# Addendum Number 01

To Drawings and Specifications dated March 10, 2024

**2024 Watkins & Rowe MS and Cy Park HS Renovations**  
**Cypress Fairbanks Independent School District**  
**CFISD Proposal Number: 24-02-5753-R-RFP**

PBK Project No's.: 240058/240059

**1 MECHANICAL PLAN - LEVEL 1 - STORAGE BUILDING**  
 Scale: 1/4" = 1'-0"

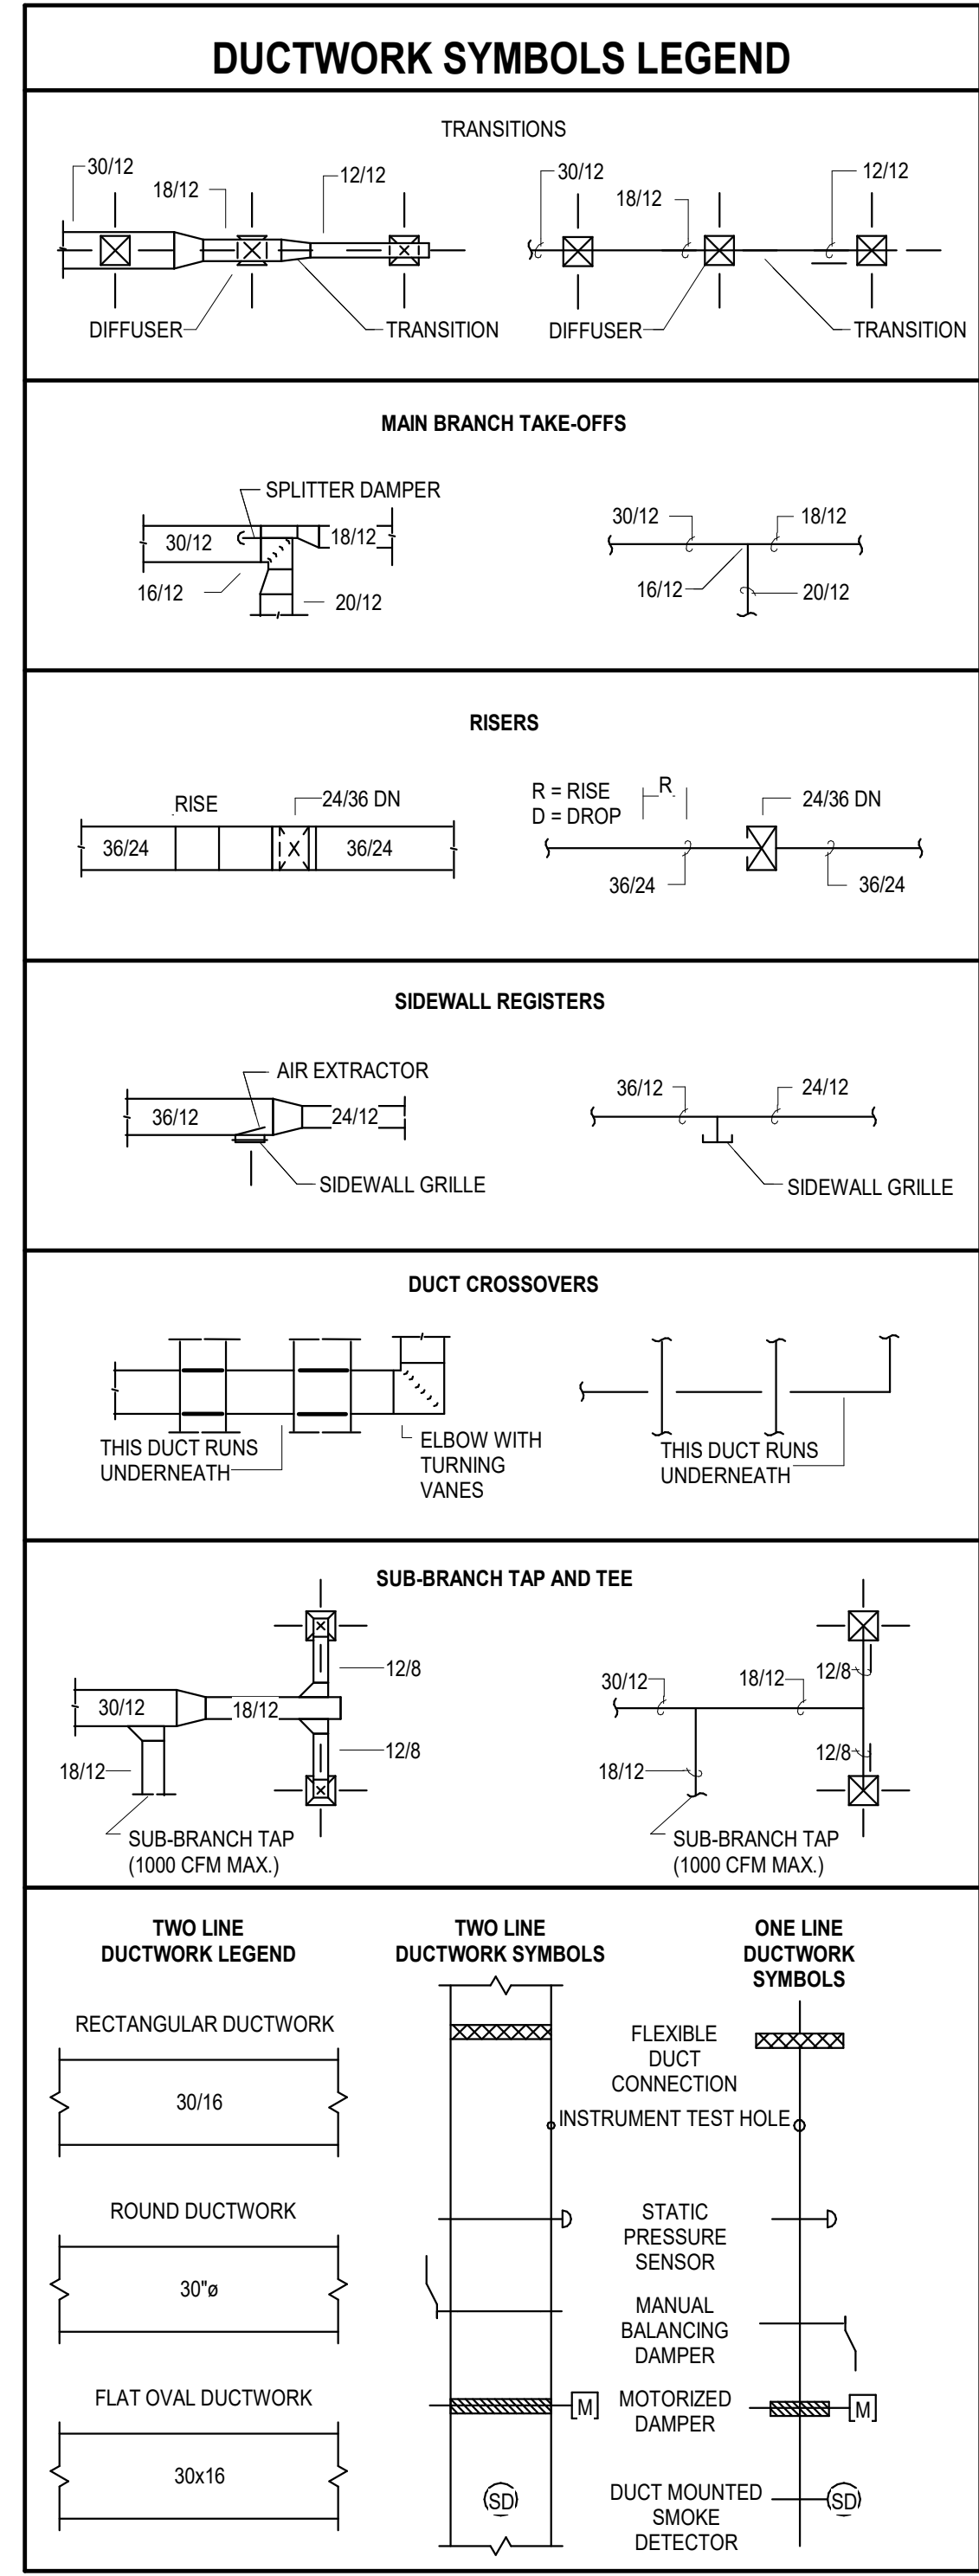
**Item No. 62** M202 - MECHANICAL FLOOR PLAN - LEVEL 1 - STORAGE BUILDING

A. Add exhaust and intake to storage building.

**1 ELECTRICAL SITE PLAN**  
 Scale: 1" = 40'-0"

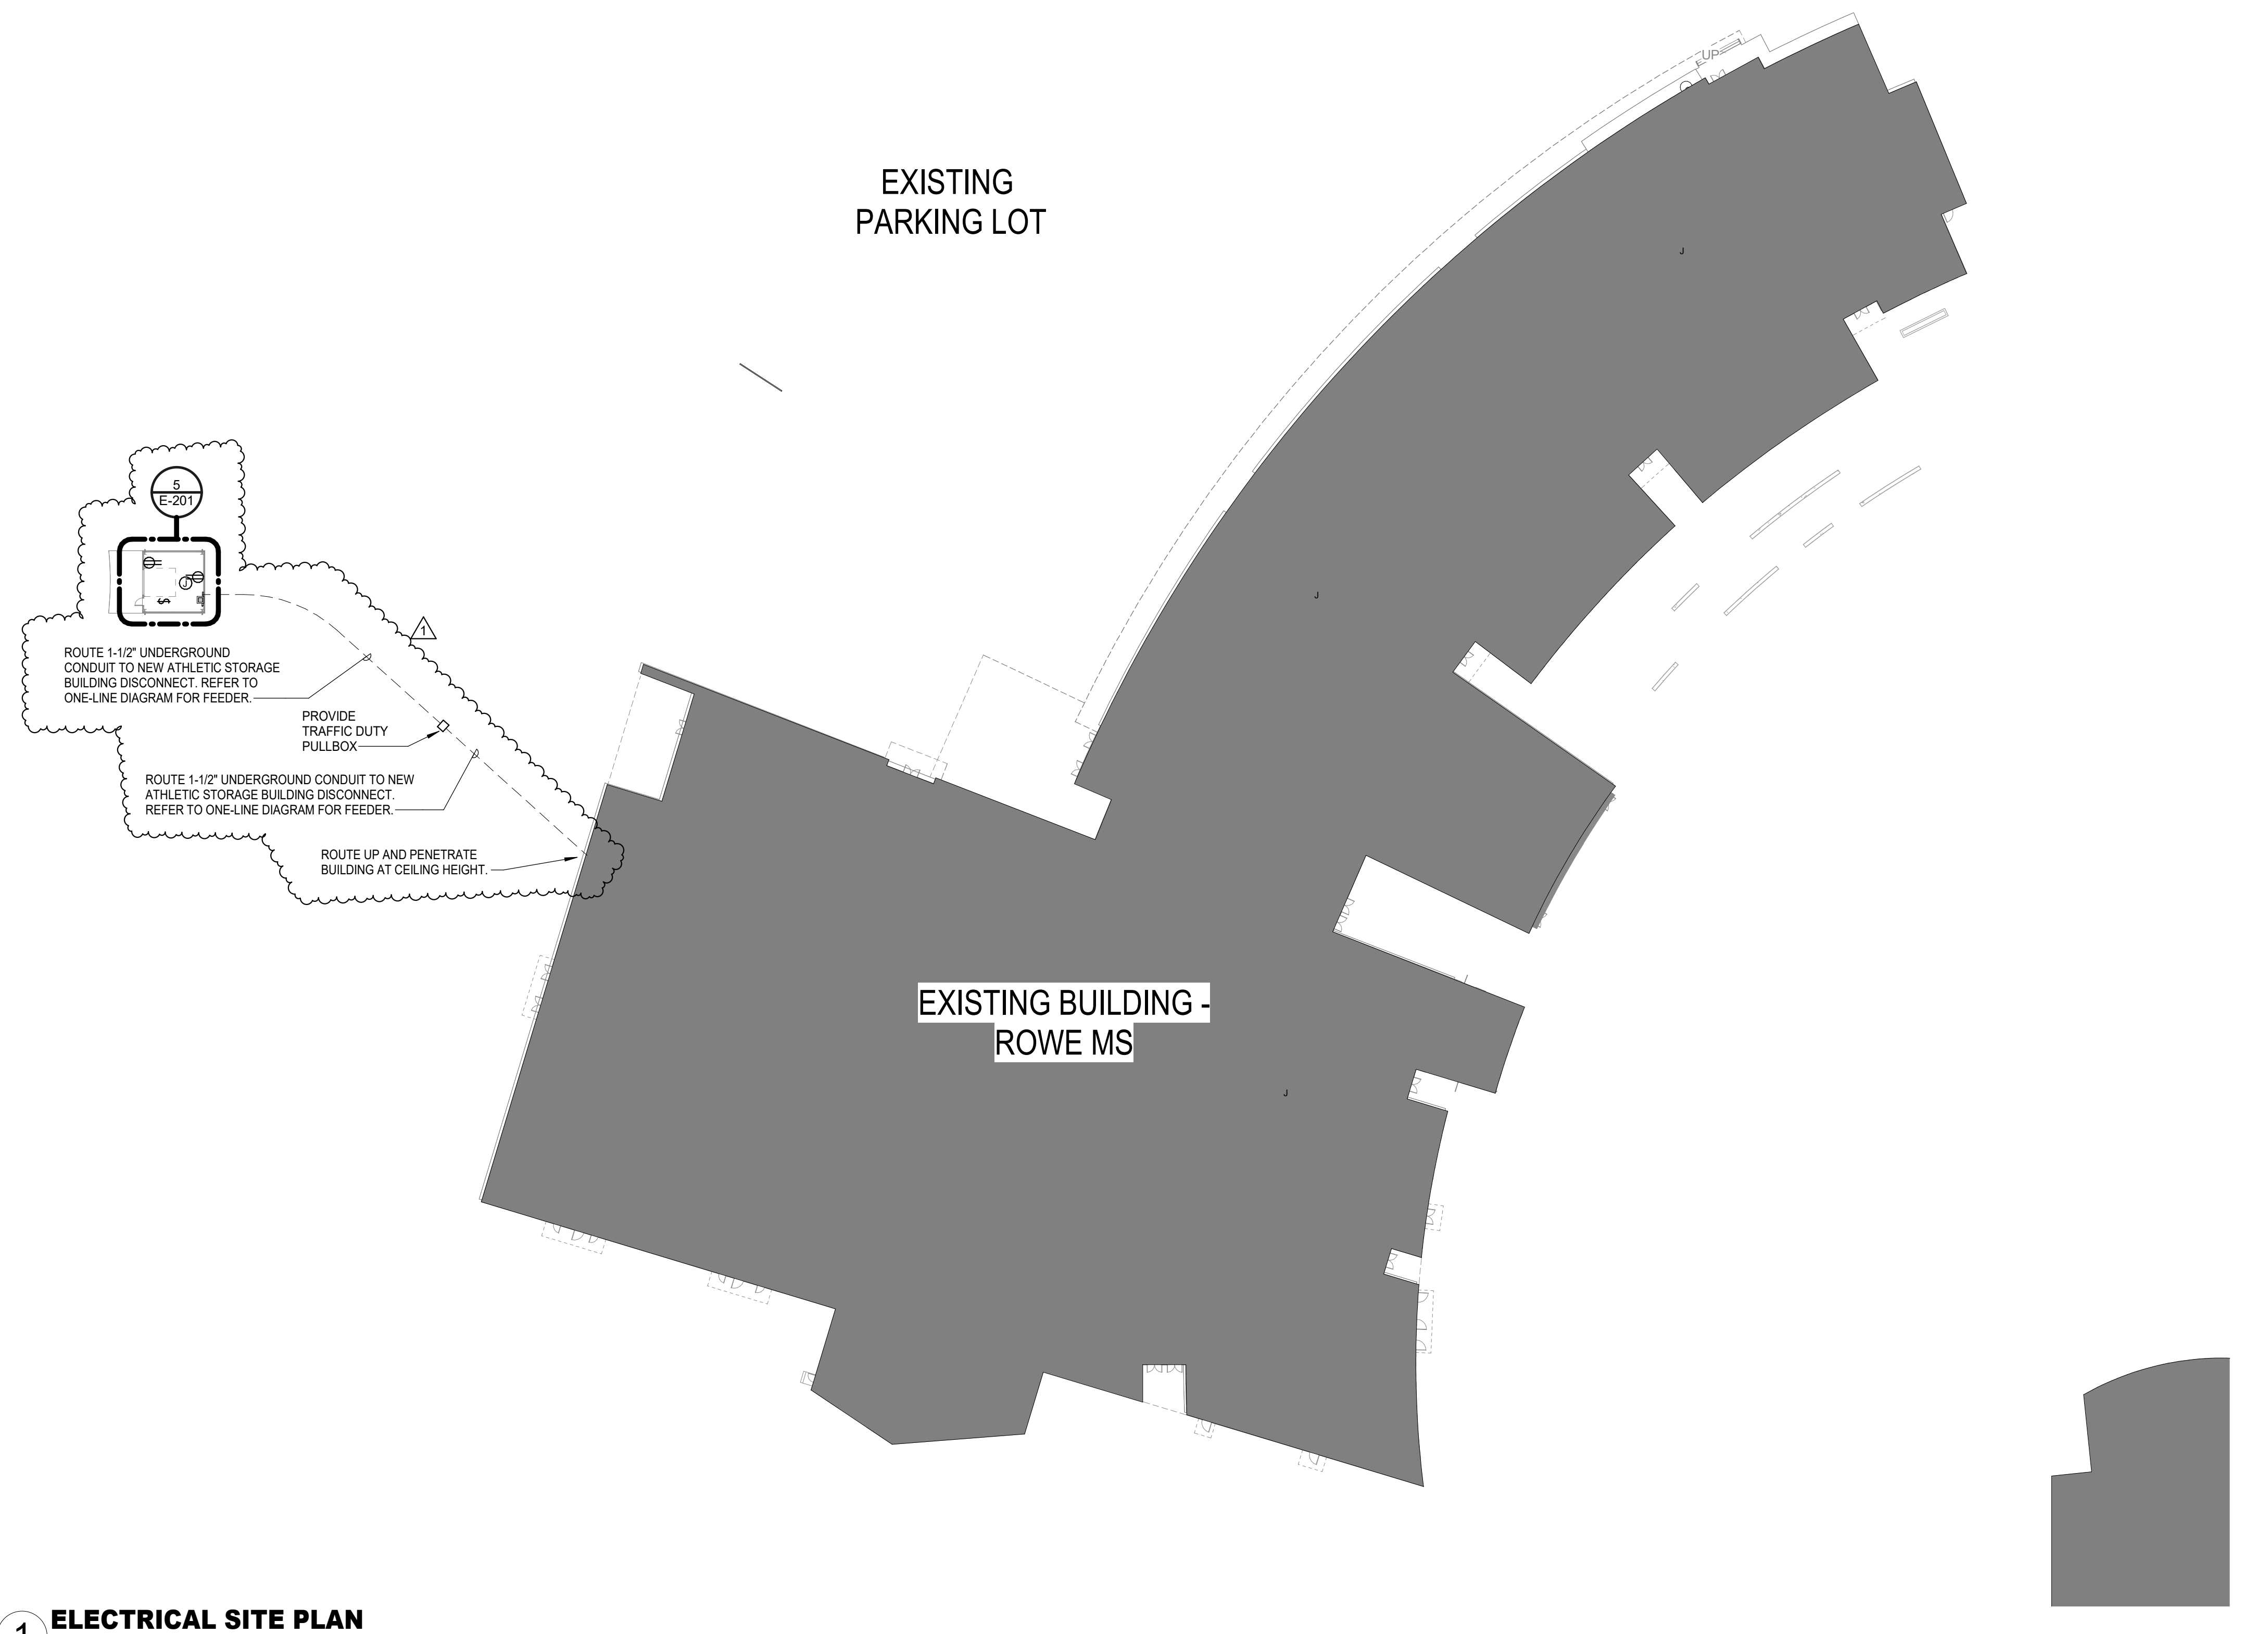
**Item No. 58** E-101 – ELECTRICAL SITE PLAN

A. Add conduit run for ne Storage Building
